**BRIDGEPORT HIGH SCHOOL PRESS BOX  
AND WEIGHT ROOM RENOVATIONS**

**ADDENDUM #3**

**April 22, 2021**

**THRASHER PROJECT #060-10117**

1 FIRST FLOOR PLAN  
MEPR 1/4" = 1'-0"

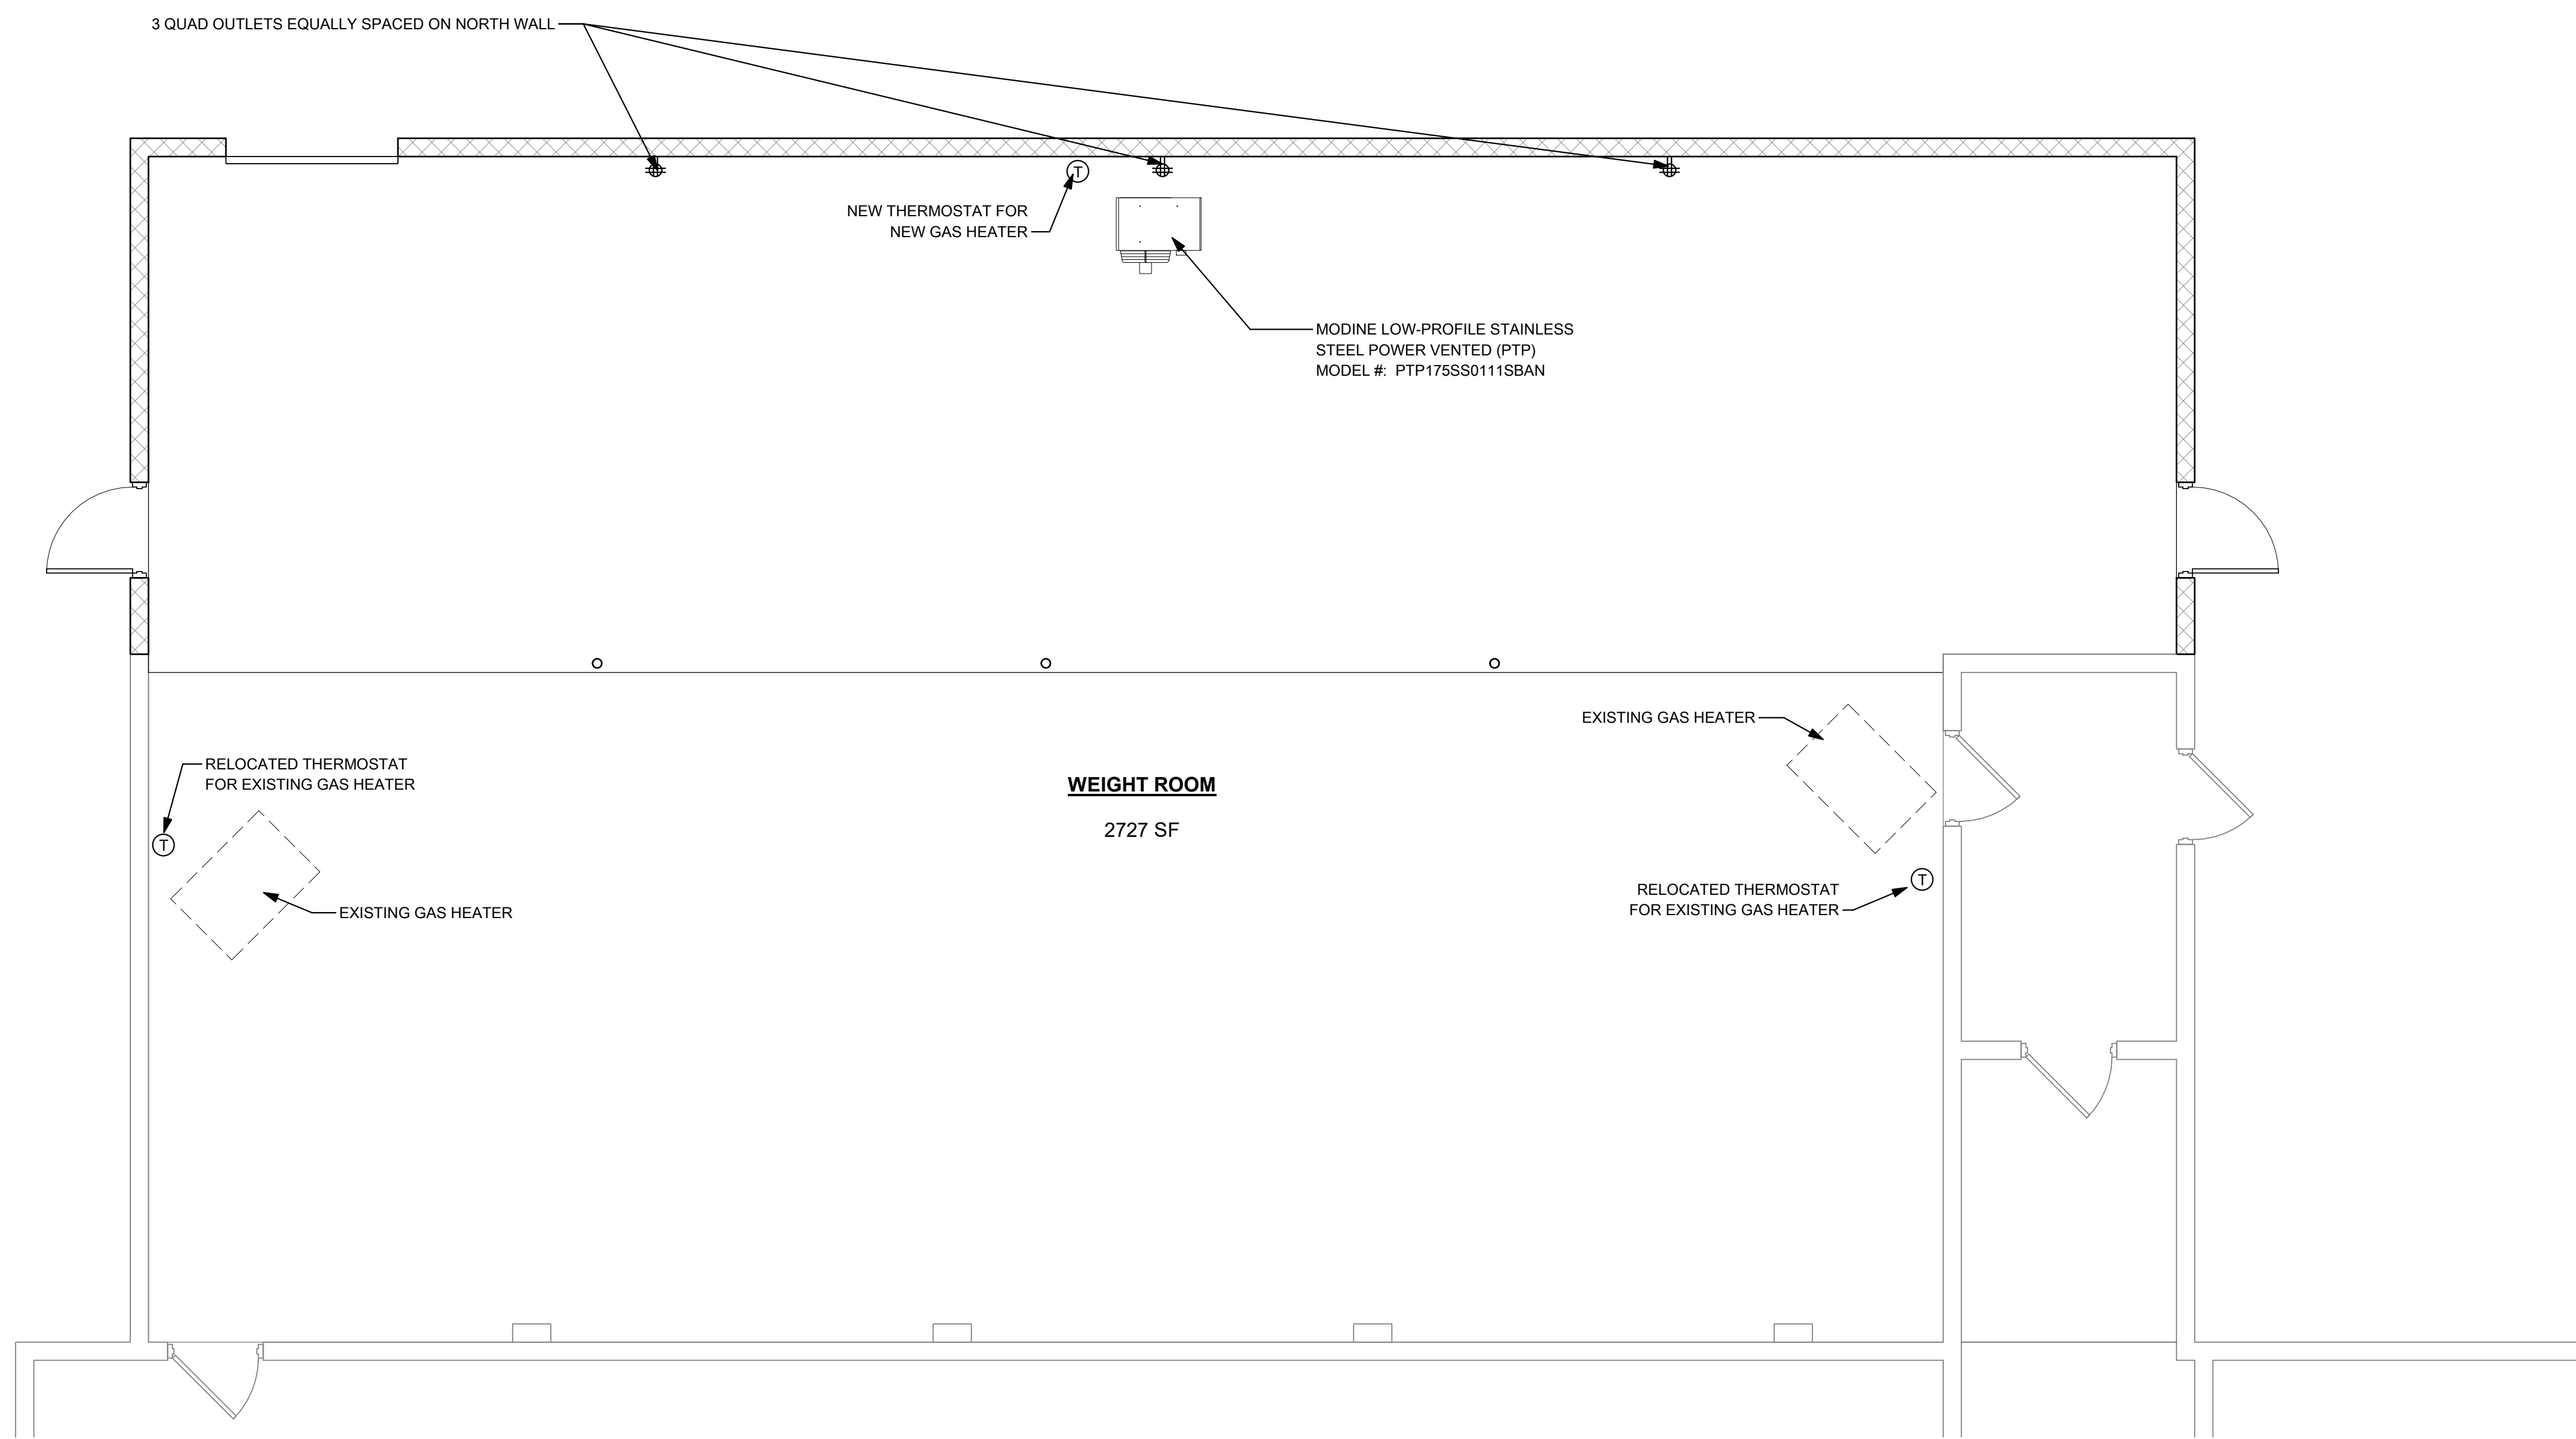
1. REVISE the location and swing of door #102 to allow clearance for new electrical box. See DRAWINGS #2 MEPR.
2. REPLACE MEP with MEPR
3. REPLACE A-MEP with A-MEPR

REMOVE EXISTING PANEL AND RE-CONNECT NEW PANEL E TO THE EXISTING FEEDER CIRCUIT AND PROVIDE NEW CIRCUIT BREAKERS FOR NEW PRESSBOX WIRING AS WELL AS RE-CONNECTING EXISTING CIRCUITS TO OTHER BUILDING AREAS OR EXTERIOR LIGHTING
